Response to Comments on Q1 2023 Progress Report Review with Comments

Date:	August 1, 2023	Jacobs Engineering Group Inc.
Project name:	Tyco Fire Products LP, One Stanton Street, Marinette, Wisconsin	1610 N 2nd Street
Project no:	D3766600	Suite 201
Attention:	Andrew Kleinberg	Milwaukee, WI 53212
Company:	U.S. Environmental Protection Agency	United States
Prepared by:	Jacobs	T +1.414.272.2426
Document no:	D3766600.305	F +1.414.272.4408
Copies to:	Sarah Krueger/WDNR Angela Carey, WDNR Ryan Suennen, Tyco Fire Products Denice Nelson, Johnson Controls Heather Ziegelbauer, Jacobs Dave Finney, Jacobs	www.jacobs.com

On behalf of Tyco Fire Products LP (Tyco), Jacobs Engineering Group Inc. (Jacobs) prepared this memorandum to respond to U.S. Environmental Protection Agency's (EPA's) and Wisconsin Department of Natural Resources (WDNR's) (collectively referred to as the Agencies) comments on the *Quarterly Progress Report (January through March 2023)* (Q1 2023 Report) dated April 14, 2023 (Jacobs 2023). This memorandum responds to the Agencies comments submitted via email on June 30, 2023.

Figure 1. Site Map
 Tyco Fire Products LP Facility
 Marinette, WI

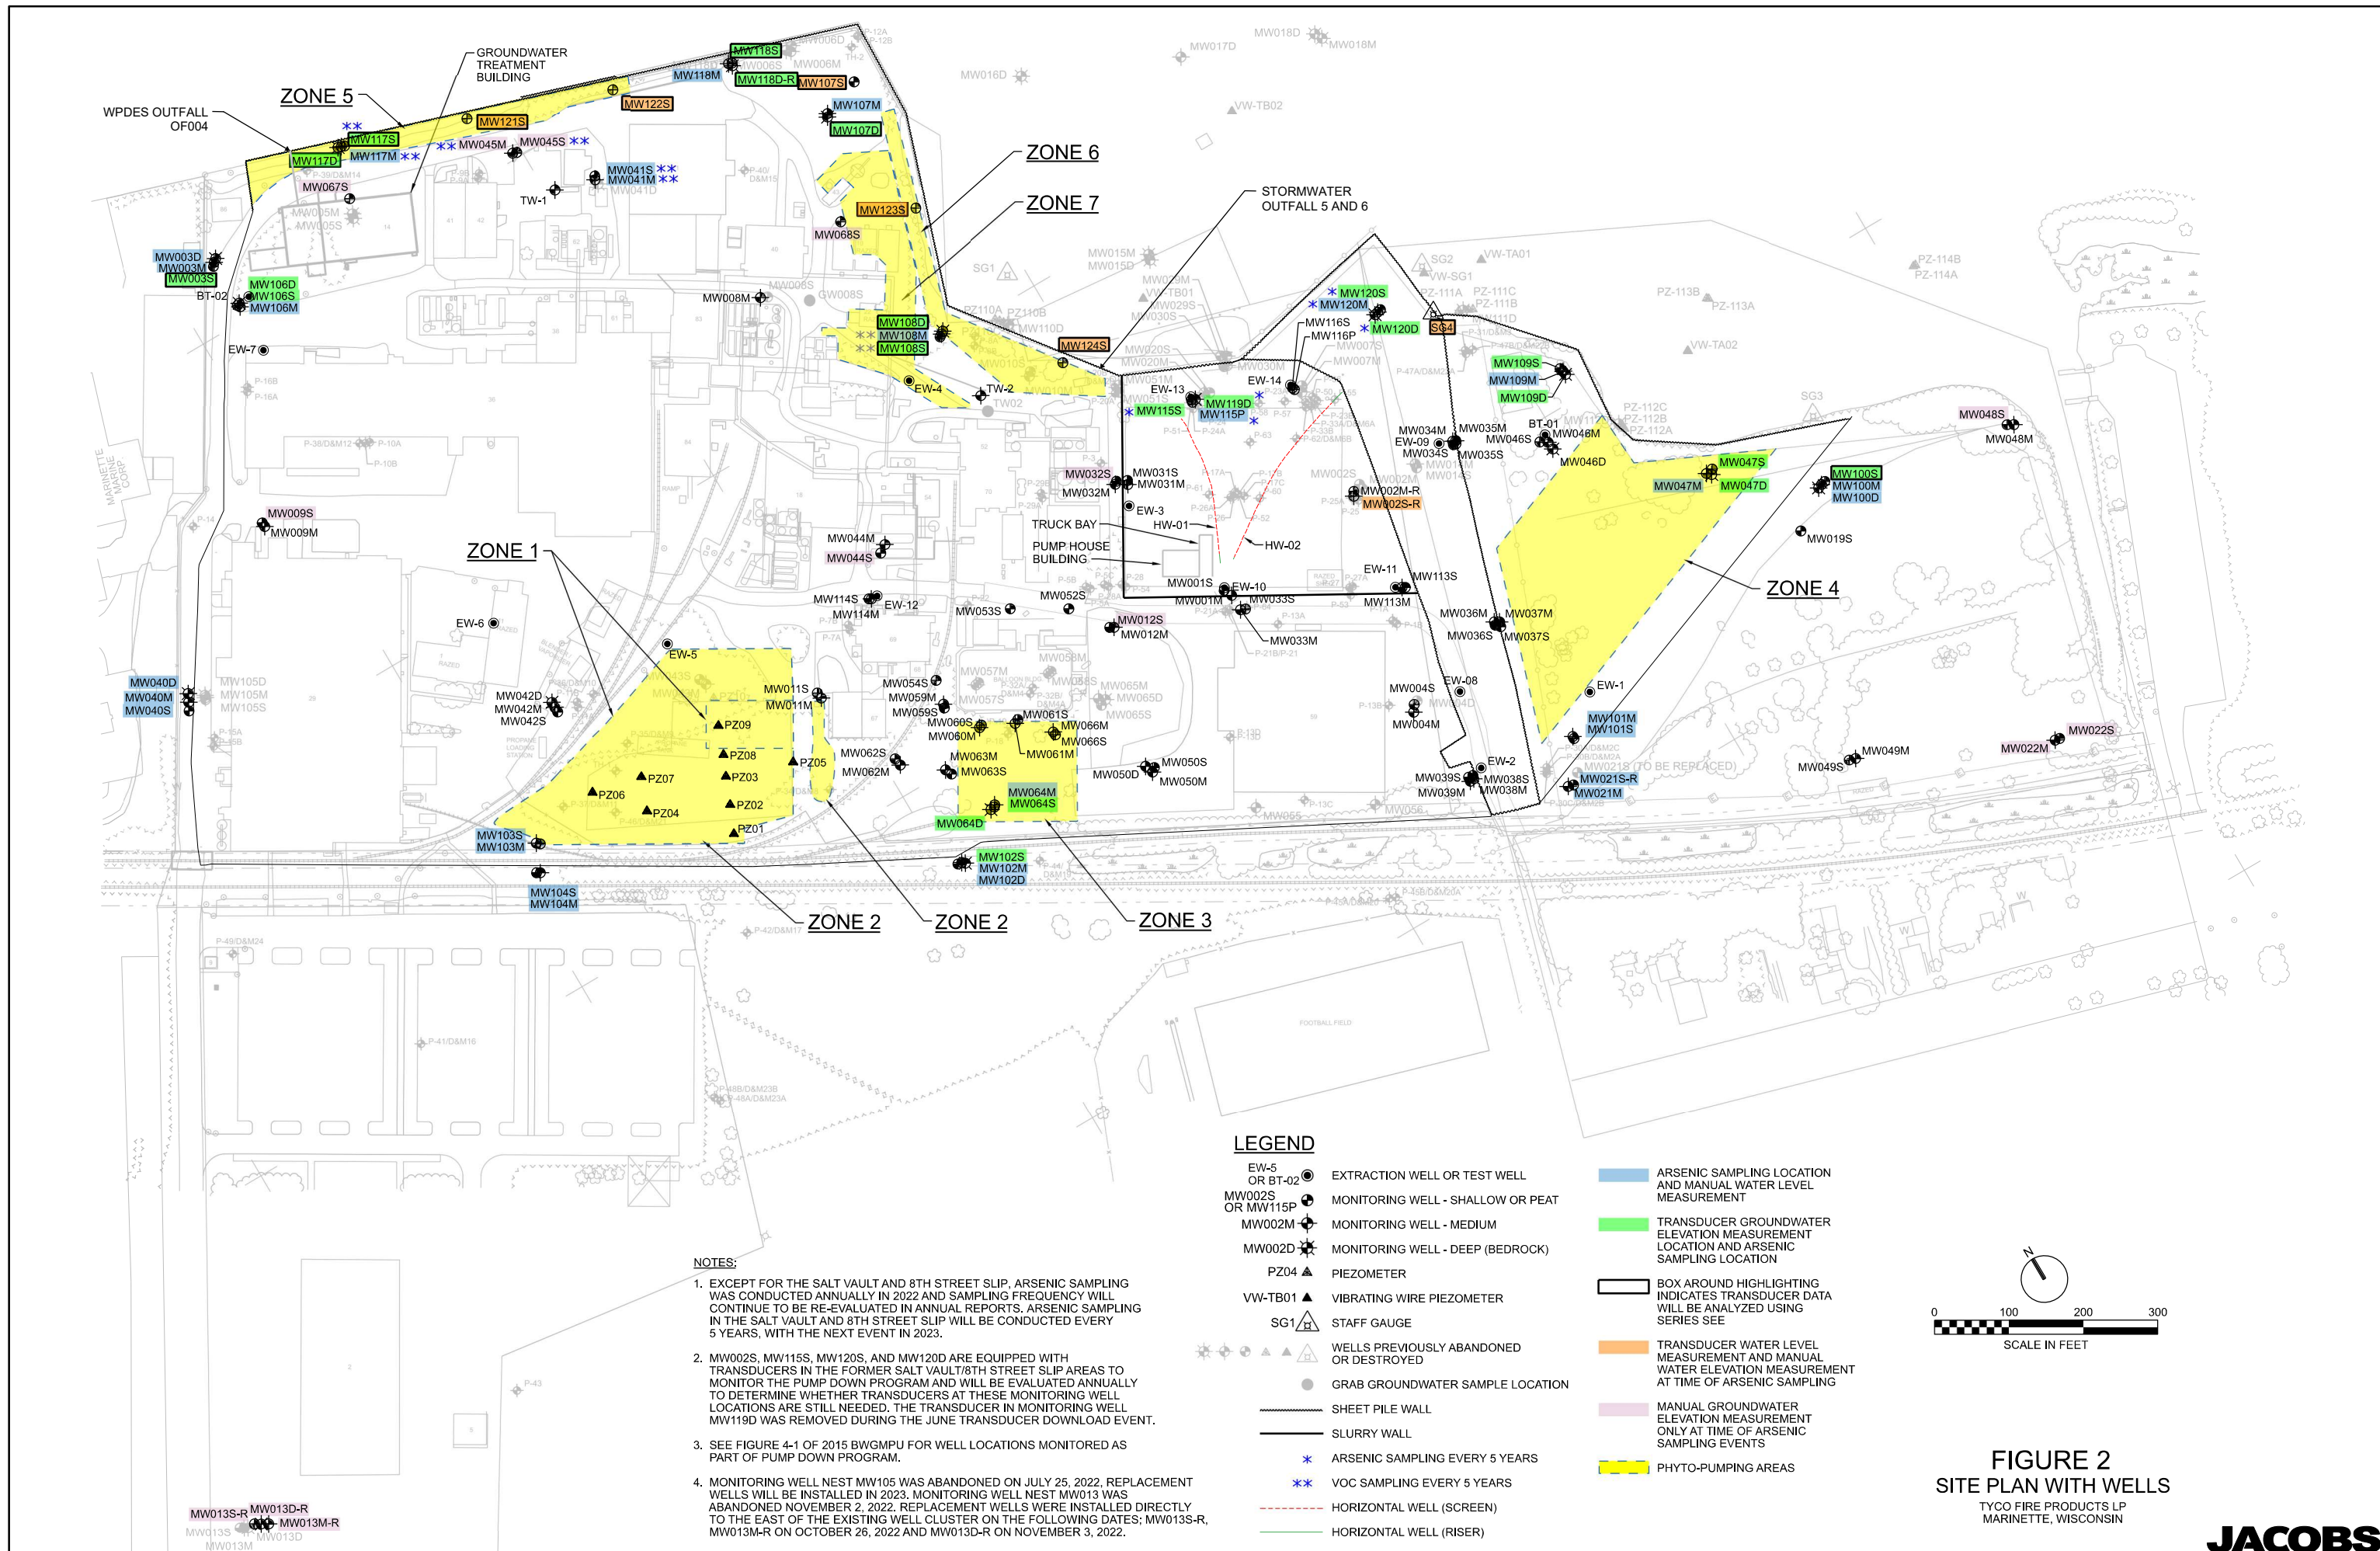
Specific Comment 2: Include a site map with features including wells, outfalls, and other relevant details for reference to Groundwater Collection Treatment System, Pump Down Program and other current or ongoing activities discussed.

Tyco Response. Three figures are attached to this response that provide additional features discussed in the Q1 2023 Report as follows:

- Figure 1 – Site Map
- Figure 2 – Site Plan with Wells and Phyto-Plot Location Map
- Figure 3 – Cover Area Location Map (this figure was included in the original Q1 2023 Report)

**Updated Attachment 4 Graph with PDP System
Hydrographs from Q1 2023 Report**

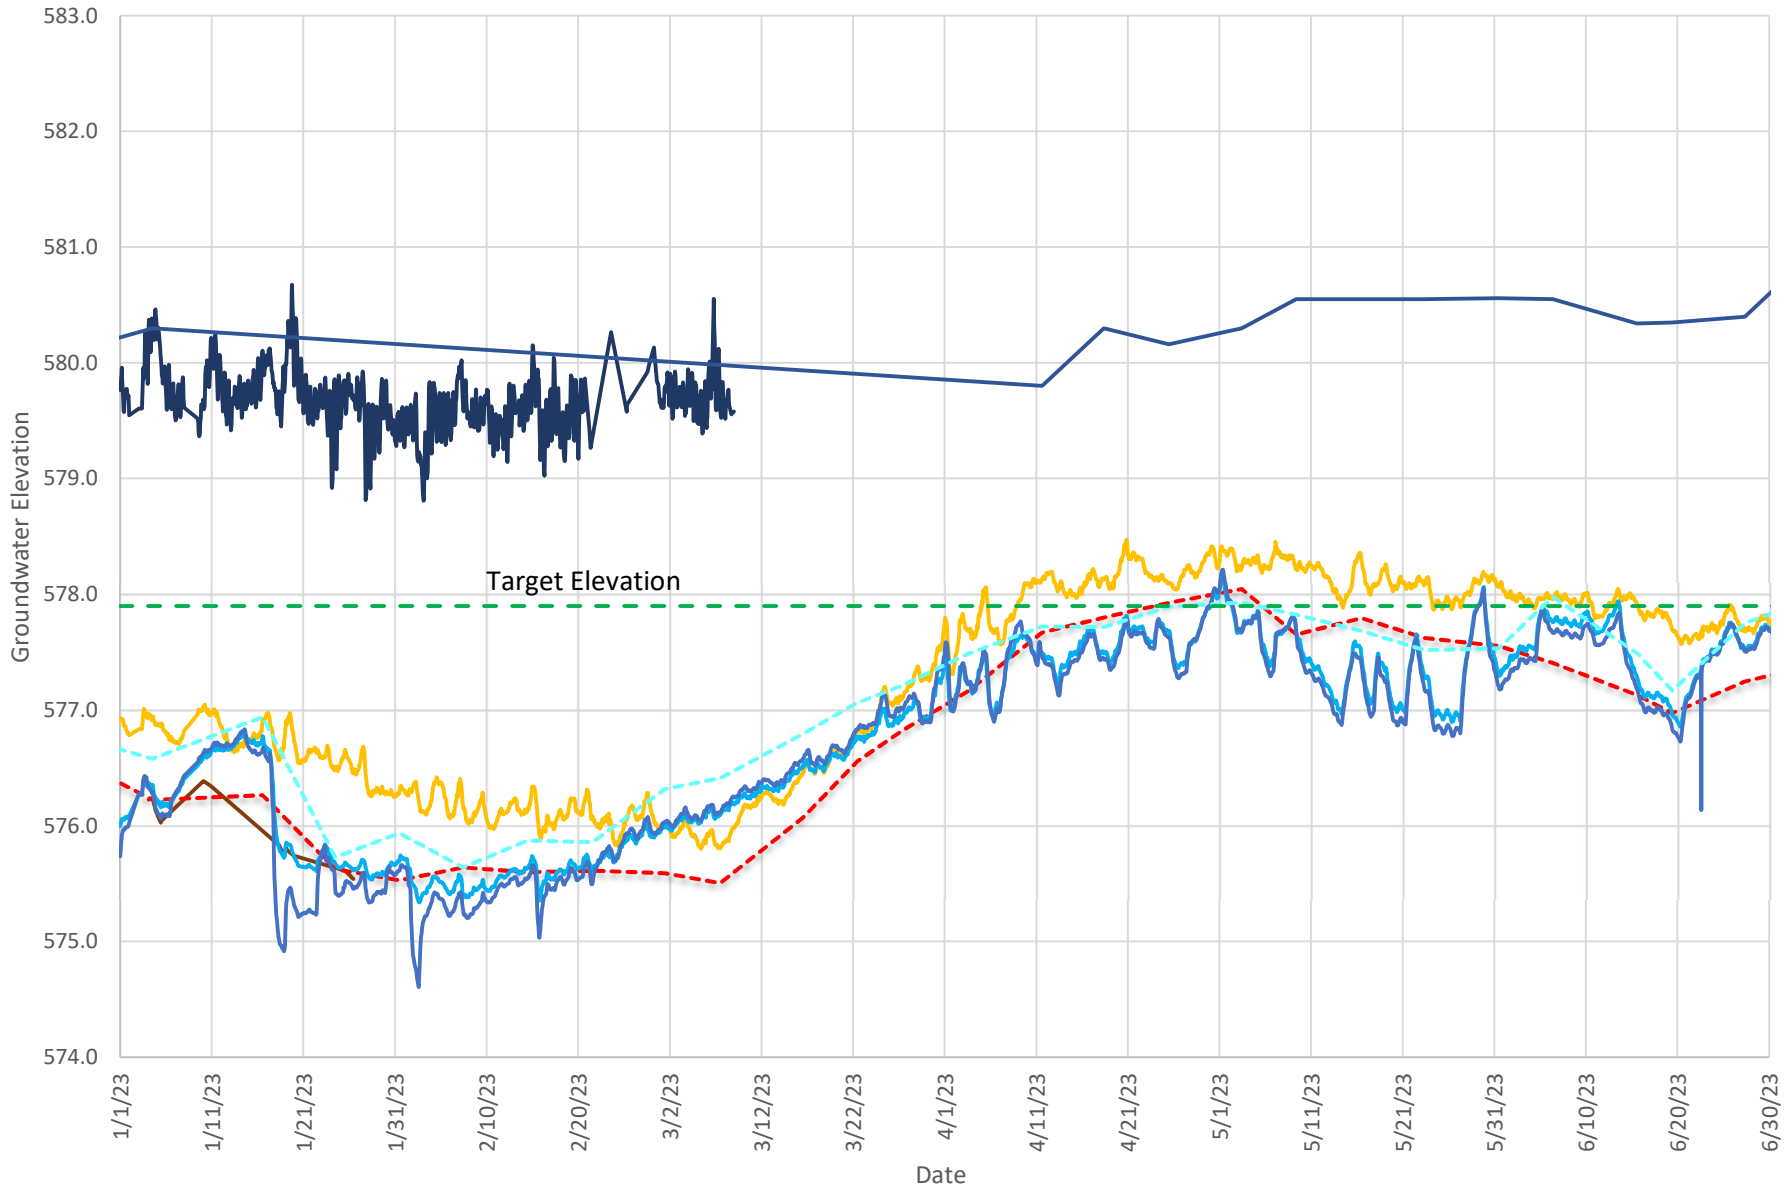
Specific Comment 5: Individual and average groundwater elevations are reported in Attachments 3 and 4. Please label the table and figure to clarify whether data is collected manually or by transducer. Include all applicable data used for averaging in Attachments 3 and 4 (e.g., groundwater elevation data for both SD4 and SW001).

Tyco Response. The Attachment 3 table and the Attachment 4 graph with the PDP system hydrographs from the Q1 2023 Report have been updated and are attached.

Attachment 3 includes only manual water level data and the data used for the averaging calculation (or Target Elevation calculation as noted in the table). The average groundwater elevation from Attachment 3 is also graphed in the Attachment 4 PDP system hydrographs. The Attachment 4 hydrographs also include the transducer data logged by the PDP system. SG4 (noted as SD4 in the comment) measurements are manual staff gauge measurements of the Menominee River that are included in Attachment 3 and was added to the Attachment 4 hydrographs. SW001 data are PDP system transducer measurements of the Menominee River that are included in the Attachment 4 hydrographs. Neither of these river level data sources are used as part of the averaging calculation.
